TITLE: Block Manager Rev D		
Document Number:		REV:
Date: 4/25/2016 6:17:50 PM	Sheet: 2/2

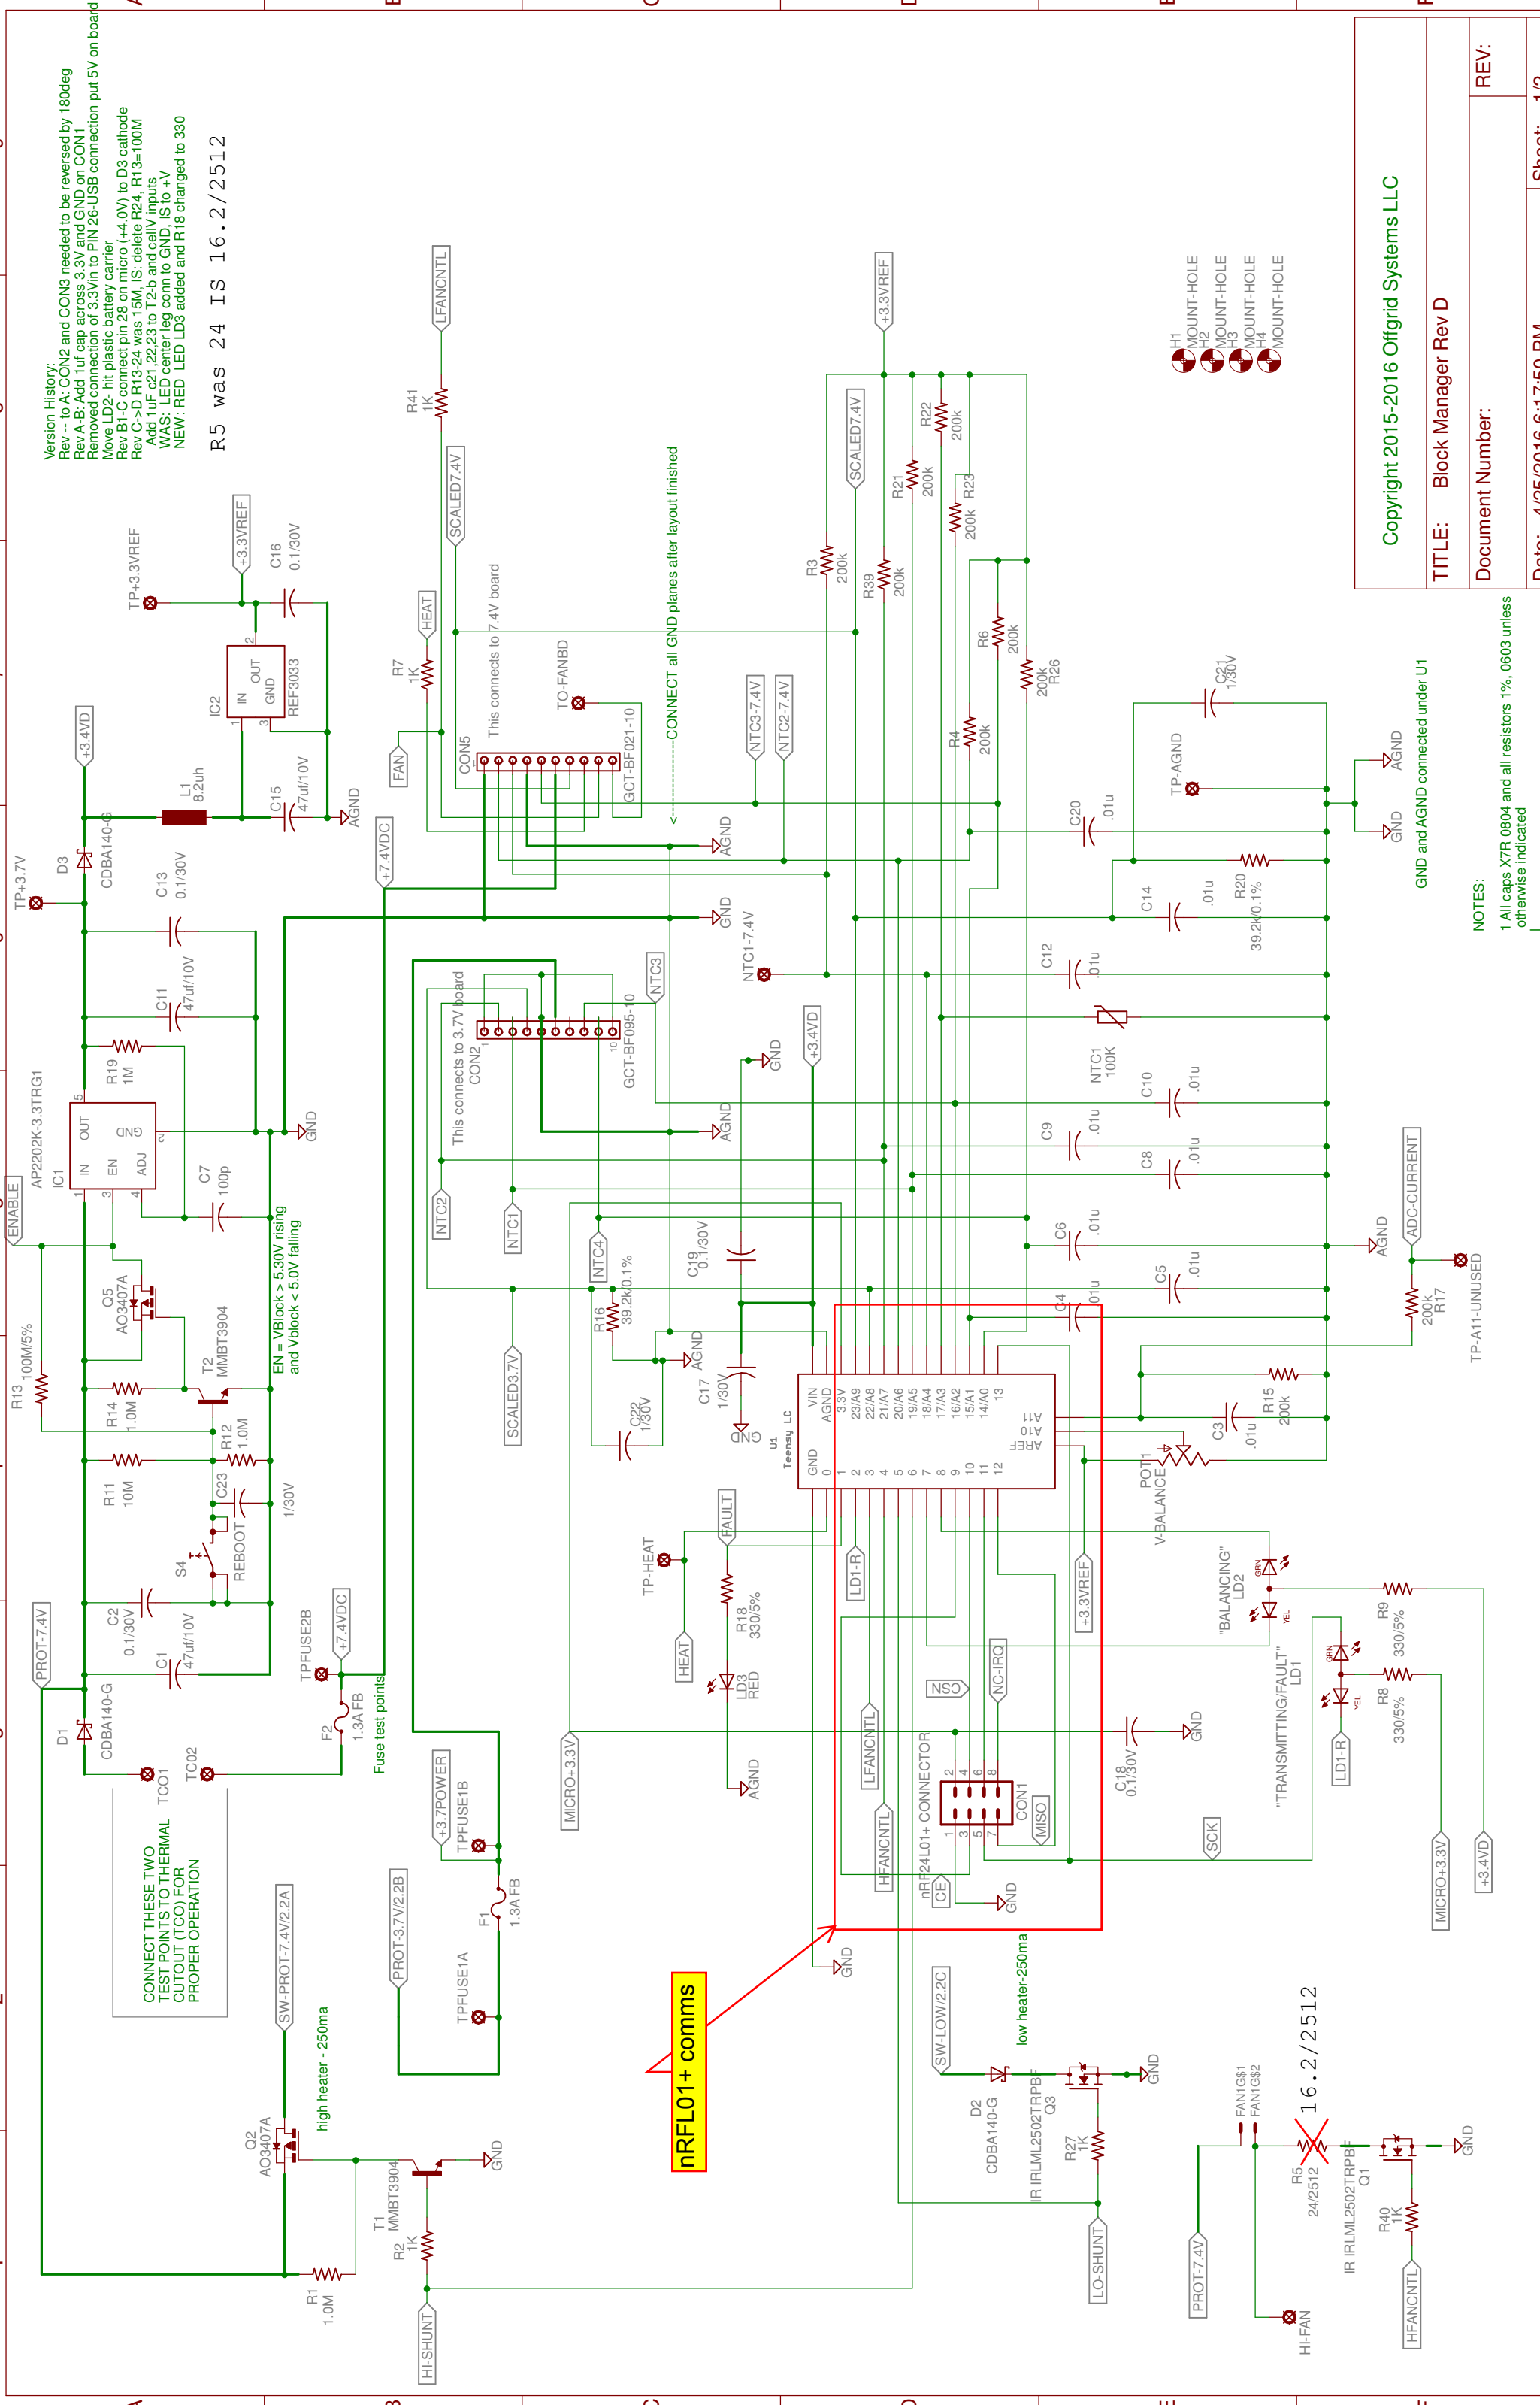
Version History:
Rev -- to A: CON2 and CON3 needed to be reversed by 180deg
Rev A-B: Add 1uf cap across 3.3V and GND on CON1
Removed connection of 3.3Vin to PIN 26-USB connection put 5V on board
Move LD2- hit plastic battery carrier
Rev B1-C connect pin 28 on micro (+4.0V) to D3 cathode
Rev C->D R13-24 was 15M, IS; delete R24, R13=100M
Add 1uF c21,22,23 to T2-b and cellIV inputs
WAS: LED center leg com to GND, IS to +V
NEW: RED LED LD3 added and R18 changed to 330

R5 was 24 IS 16.2/2512

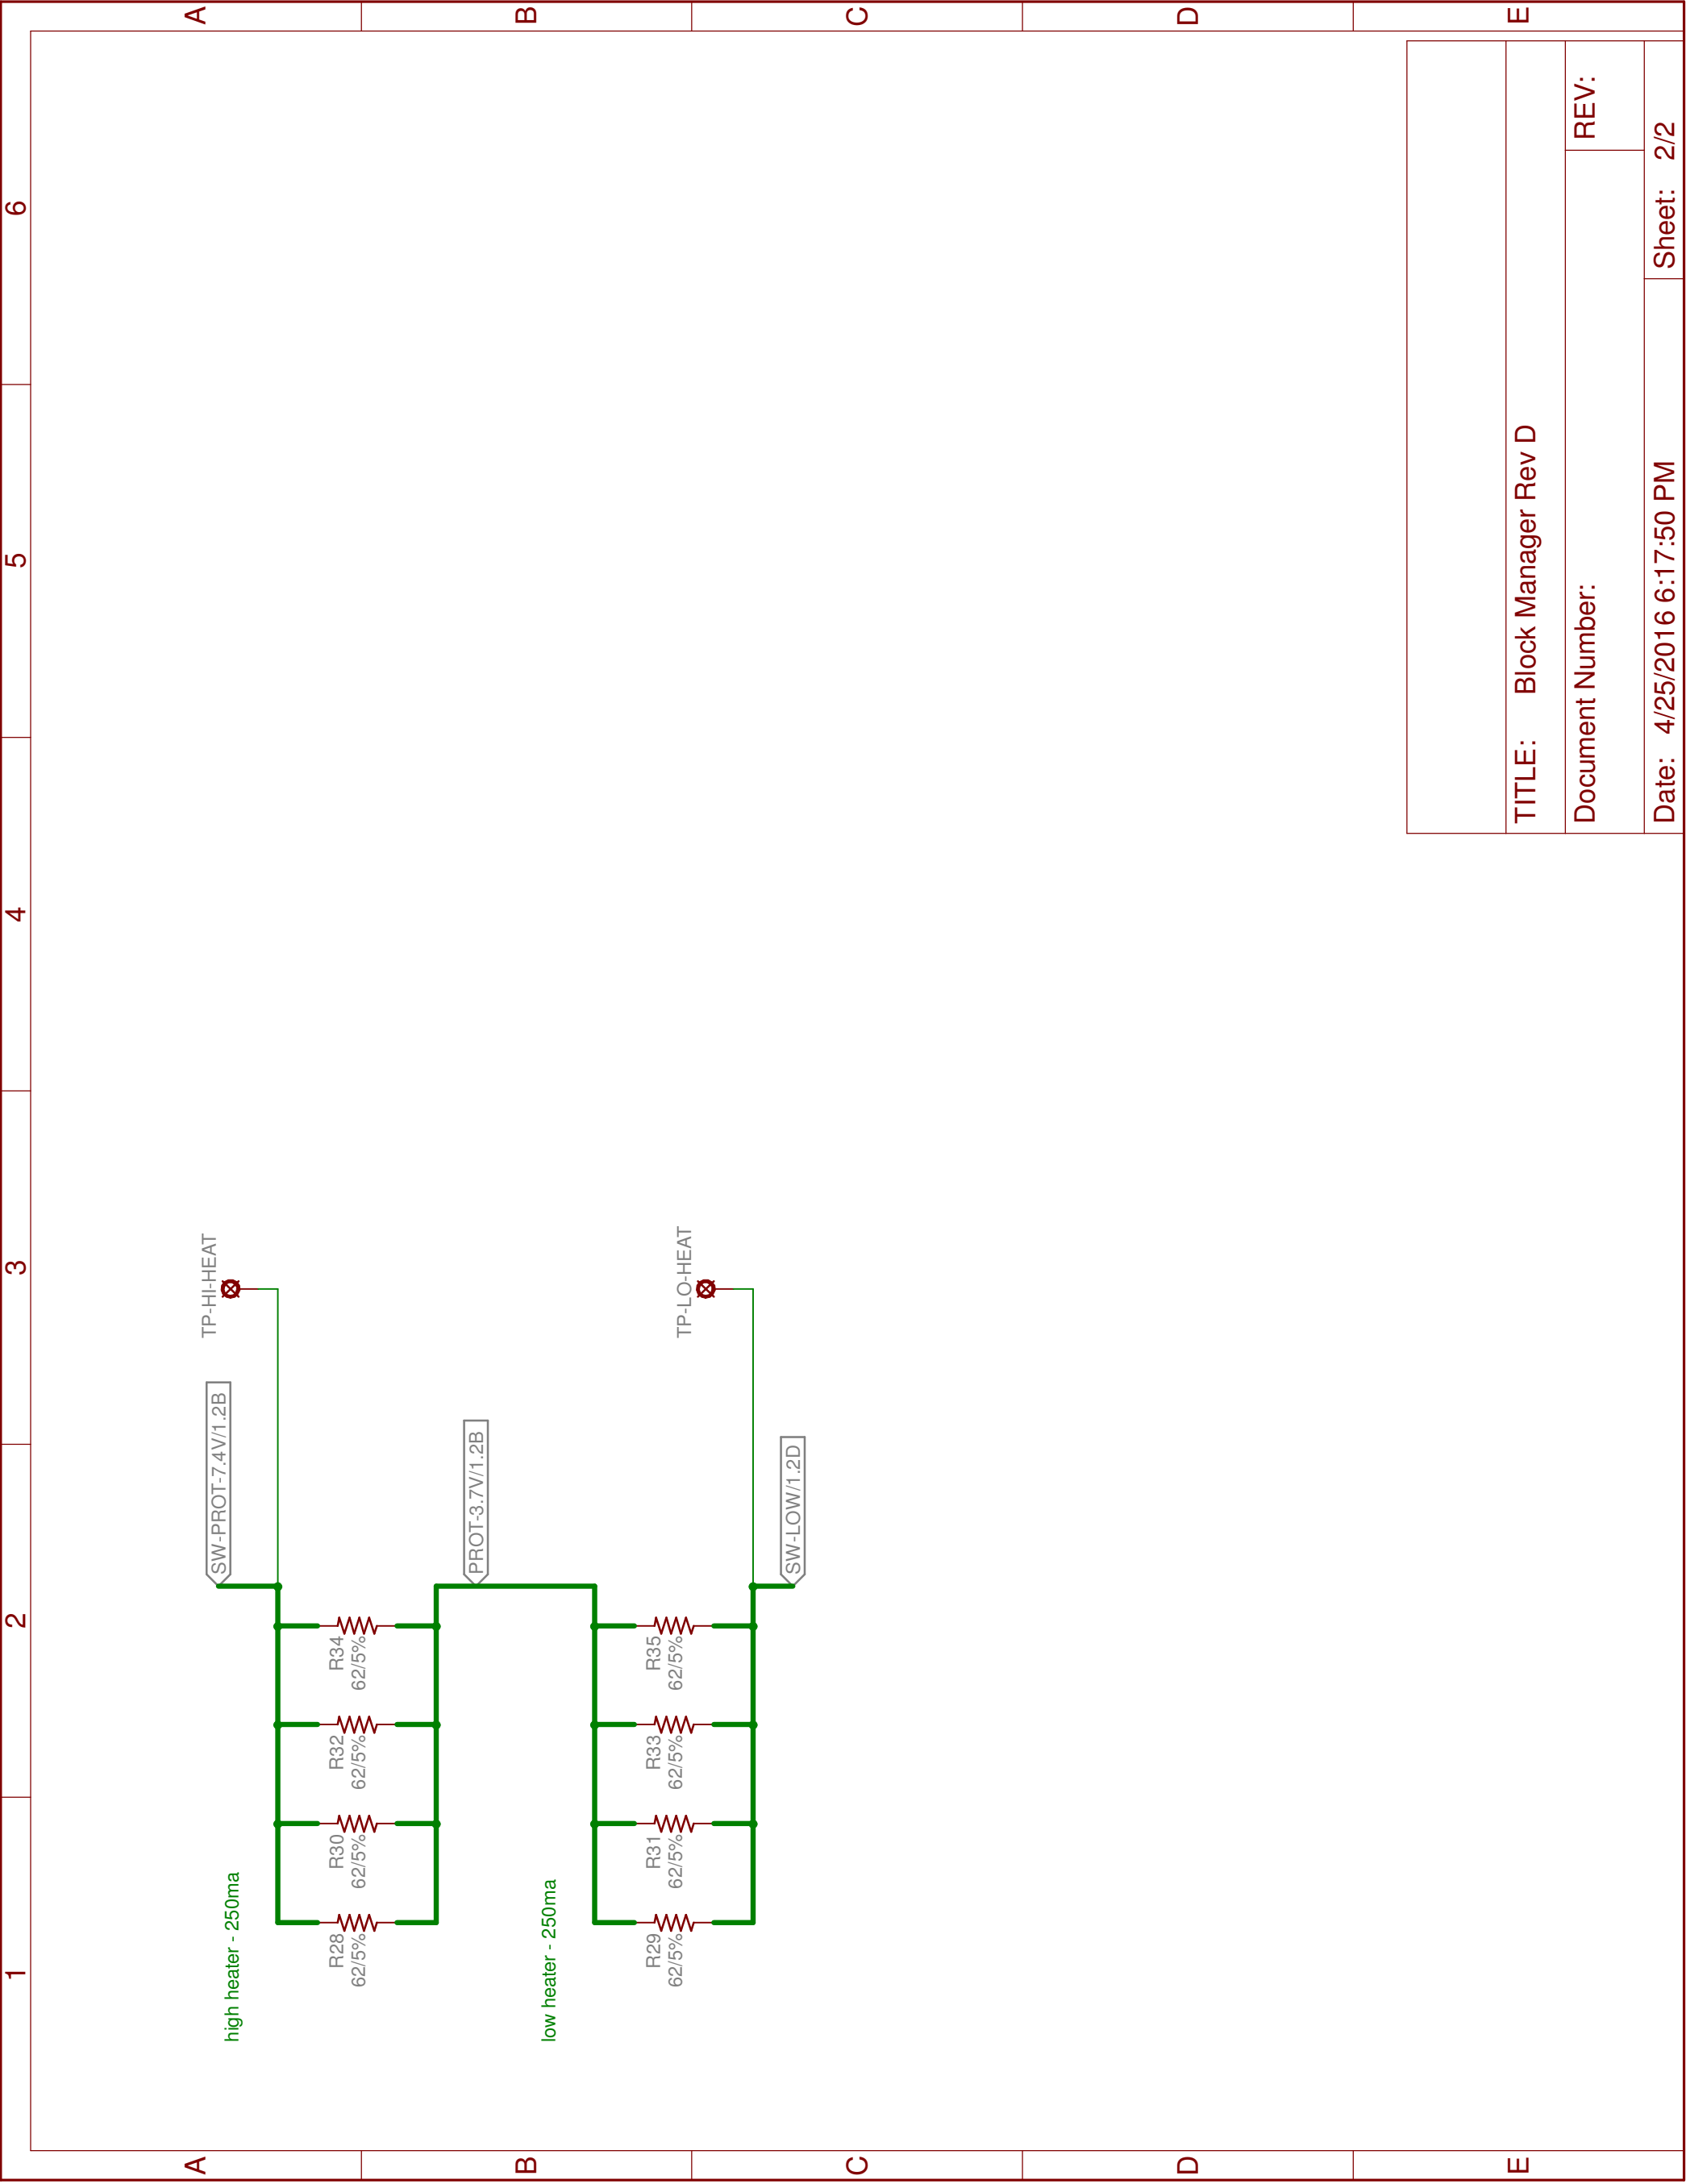
CONNECT THESE TWO TEST POINTS TO THERMAL CUTOFF (TCO) FOR PROPER OPERATION
